MAINE TURNPIKE AUTHORITY

ADDENDUM NO. 1

CONTRACT 2019.09

BRIDGE IMPROVEMENTS
MAINE CENTRAL RAILROAD OVERPASS
MILE 47.9

SHEET NUMBER: BMP-1
CONTRACT: 2019.09
23 OF 116

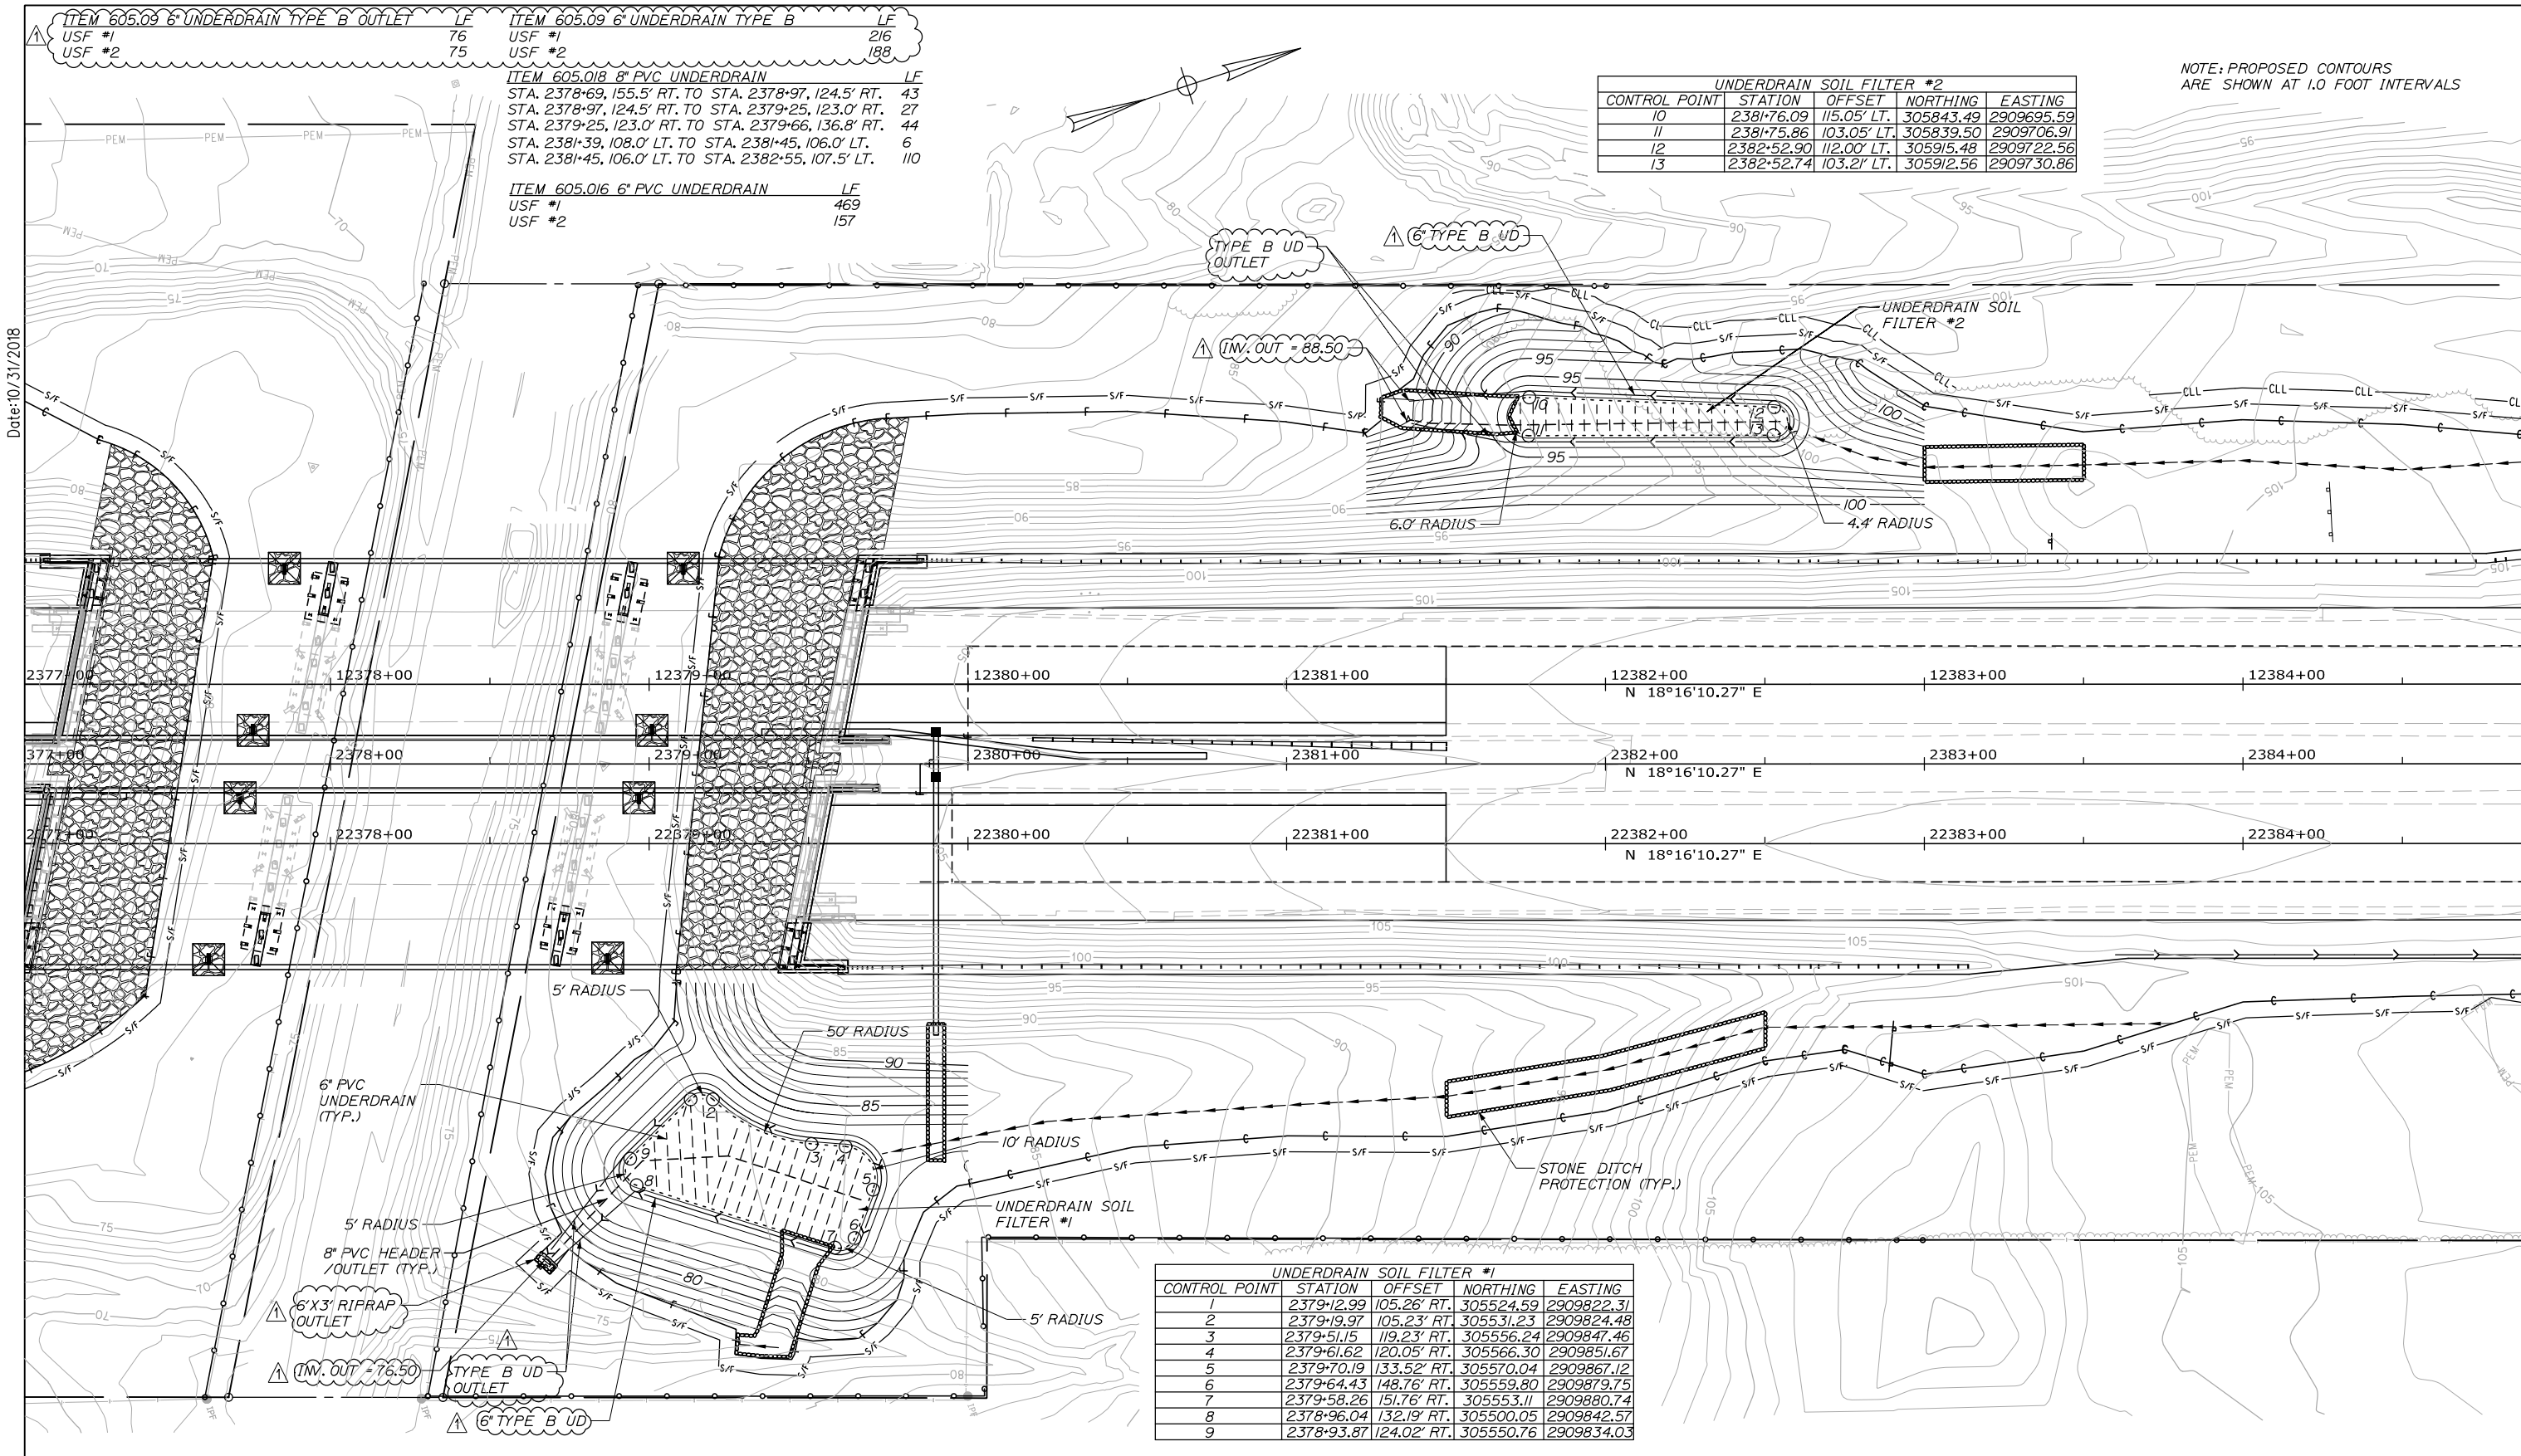
3. MAINE CENTRAL RAILROAD PART II, Plan Sheet BMP-1, sheet 23 of 116 “Underdrain Soil Filter Detail, Estimated Quantities”: This plan sheet is removed in its entirety and replaced with the attached revised sheet 23.

Scale: AS NOTED			
No.	Revision	By	Date
1	IMPERVIOUS LINER	JRH	10/18

This work shall consist of installing an impervious liner in between two layers of drainage geotextile at each of the two underdrain soil filter locations shown on the plans.

The Impervious Liner shall be installed on all sides and the bottom of the underdrain soil filter and extend up the slope to an elevation greater than the top elevation of ponding required for water quality volume. Install drainage geotextile on both sides of the impervious liner to protect the liner from puncture and in accordance with the manufacturer's recommendations as shown on the plans.

SHEET NUMBER: BMP-2

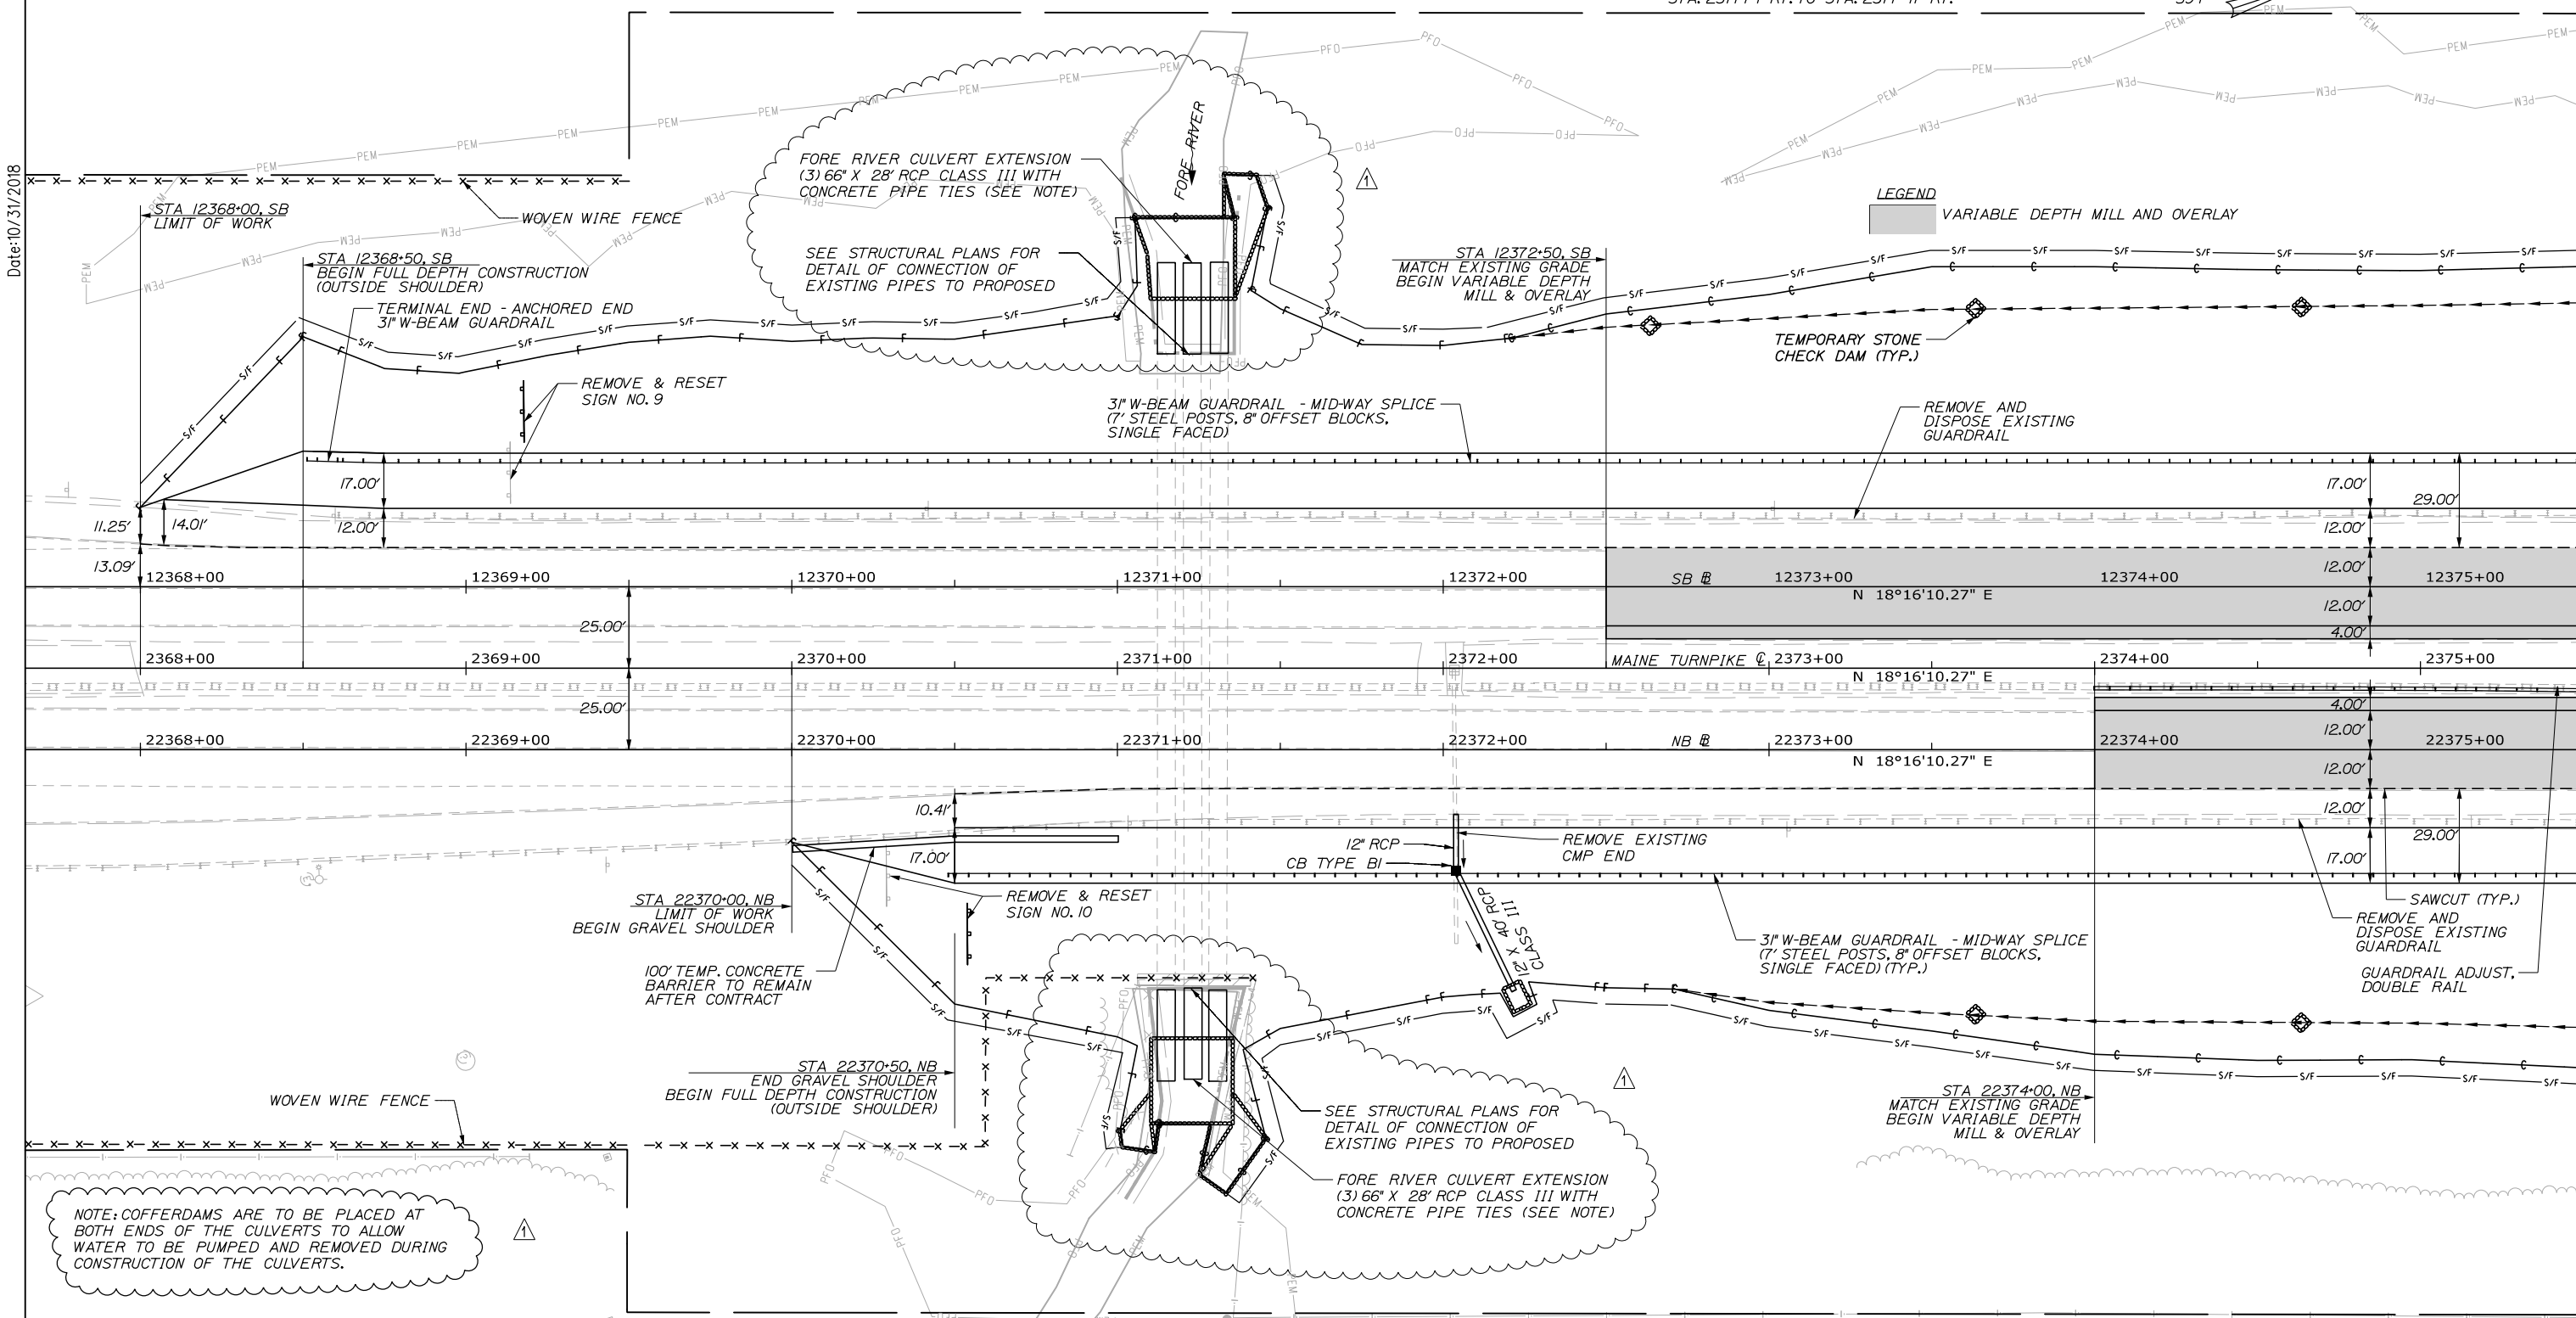
4. MAINE CENTRAL RAILROAD PART II, Plan Sheet BMP-2, sheet 24 of 116 “Grading Plan, Estimated Quantities”: This plan sheet is removed in its entirety and replaced with the attached revised sheet 24.

SHEET NUMBER: GP-01
25 OF 116

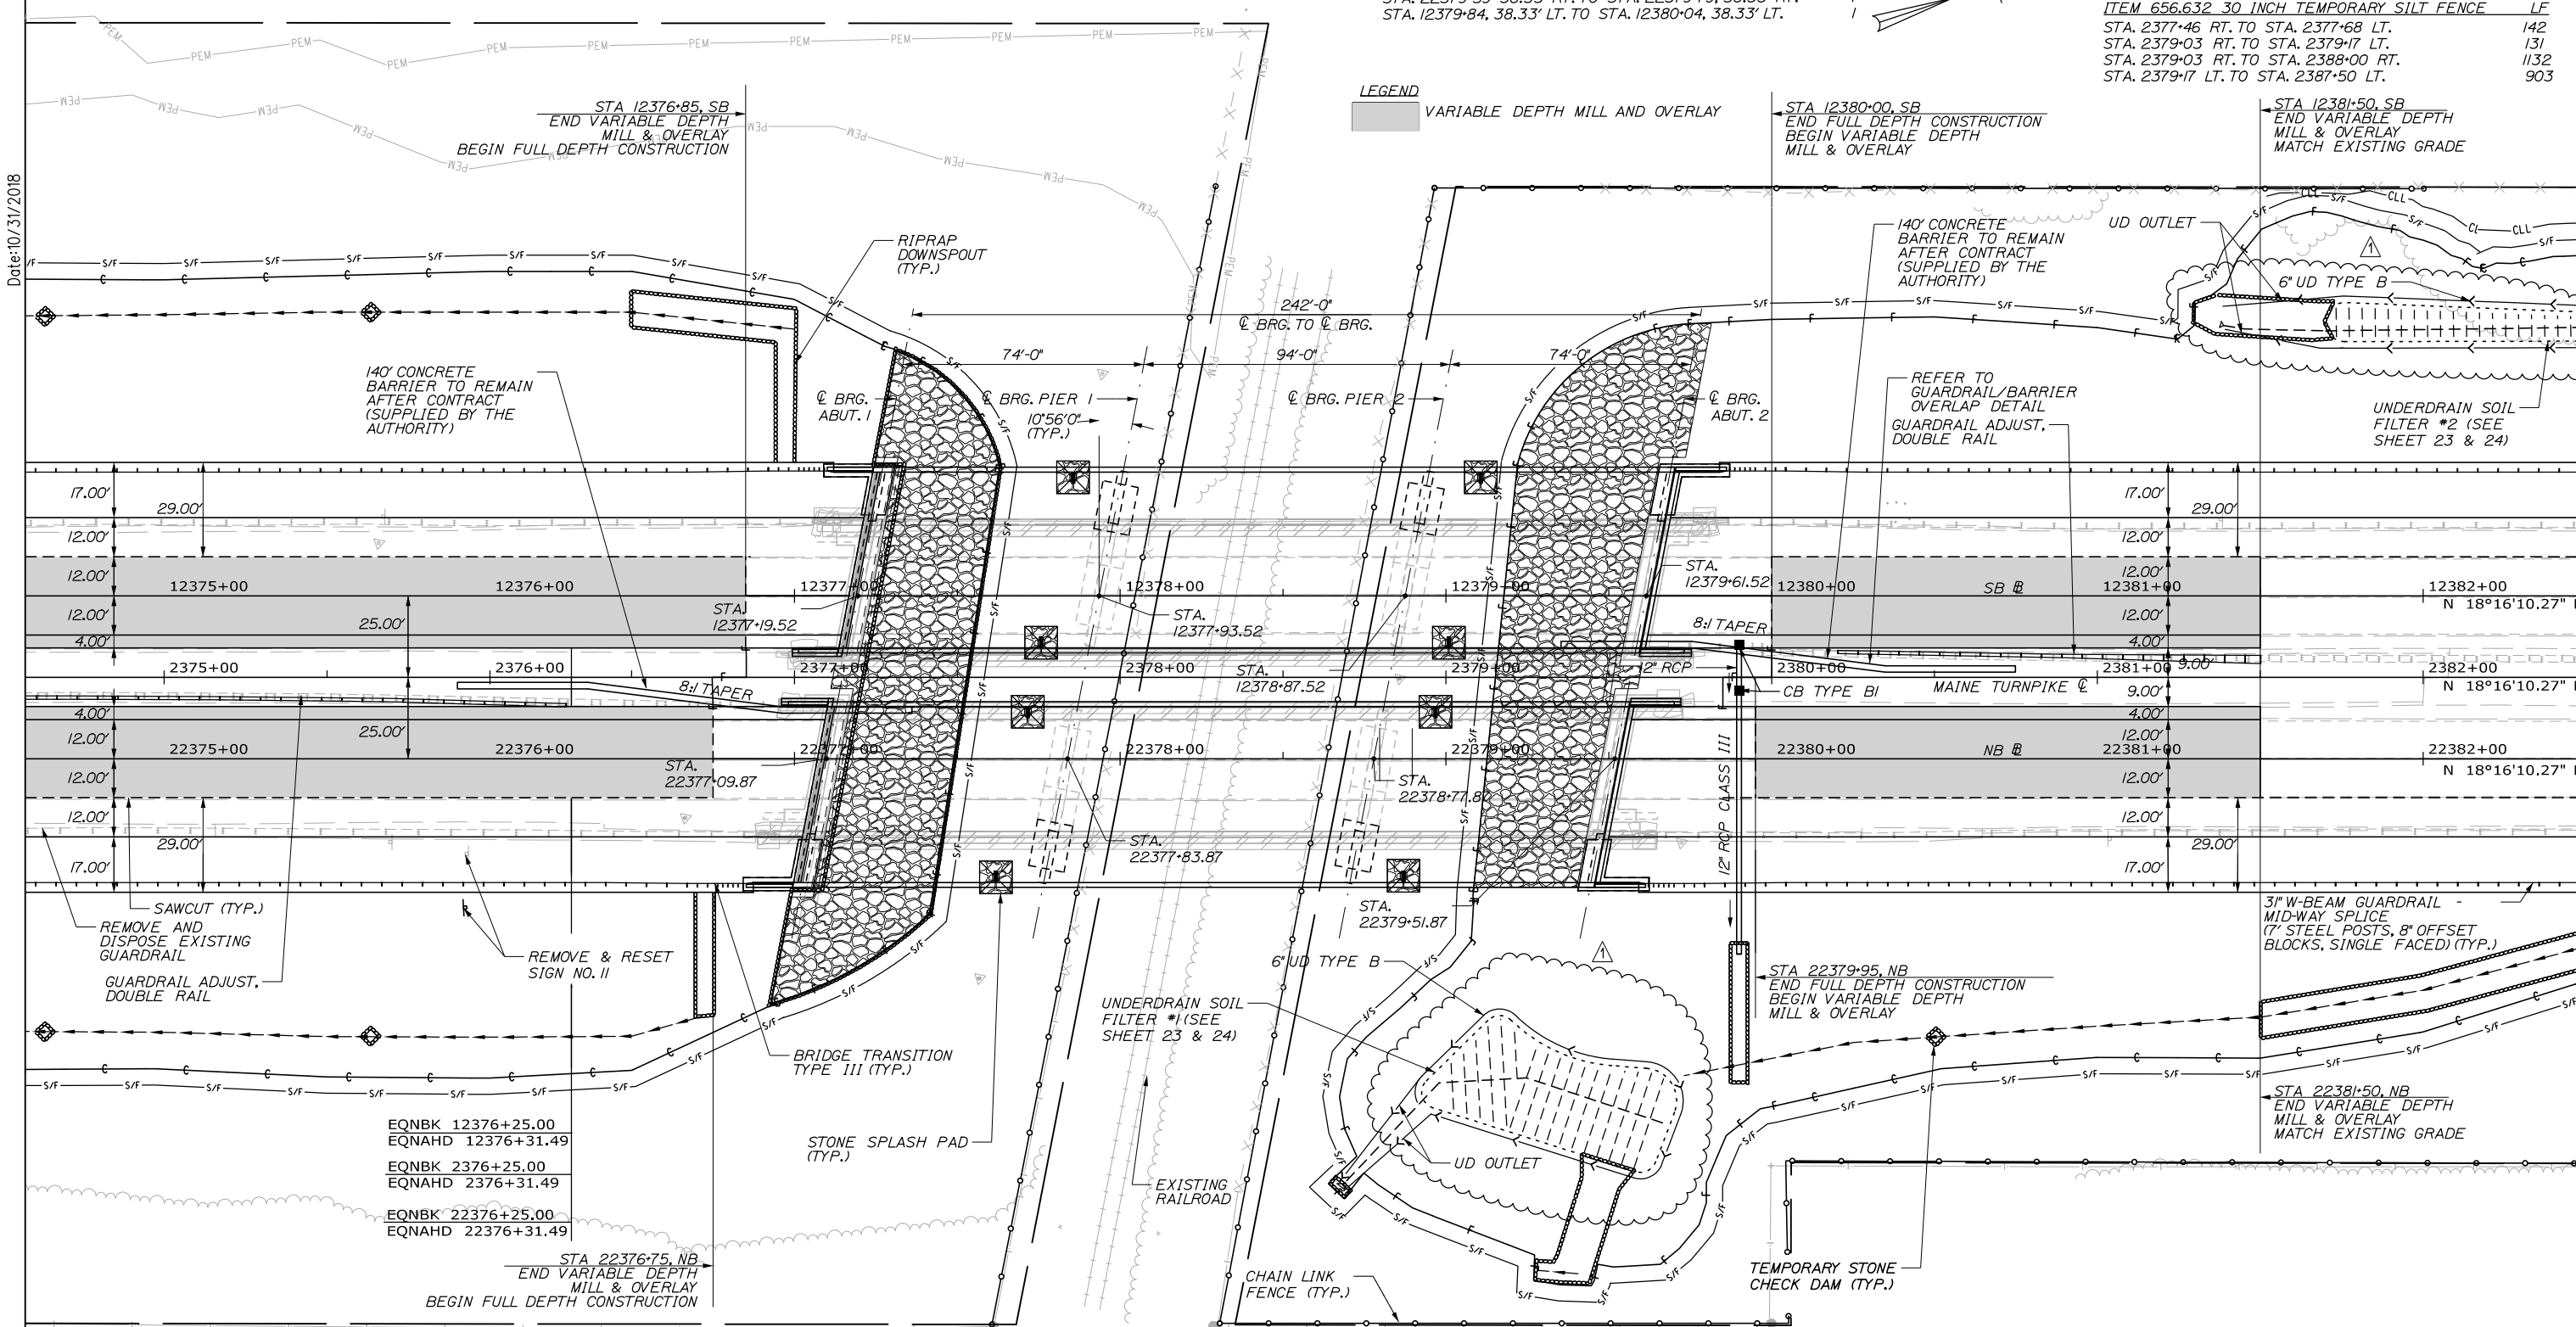
5. MAINE CENTRAL RAILROAD PART II, Plan Sheet GP-01, sheet 25 of 116 “General Plans 1”: This plan sheet is removed in its entirety and replaced with the attached revised sheet 25.

Answer: The sheet pile wall shown on the Plans is deleted. In lieu of installing a sheet pile wall system the Contractor shall extend the existing Fore River culverts as shown on the revised plan sheets. Note that this work will not be allowed to occur until after approved permits are received from MaineDEP and the U.S. Army Corps of Engineers. These permits are expected to be received on or before July 2019. Additionally, all work related to the culvert extensions shall be completed during the designated in-stream work windows defined in Special Provision 107.4.6, Prosecution of Work.
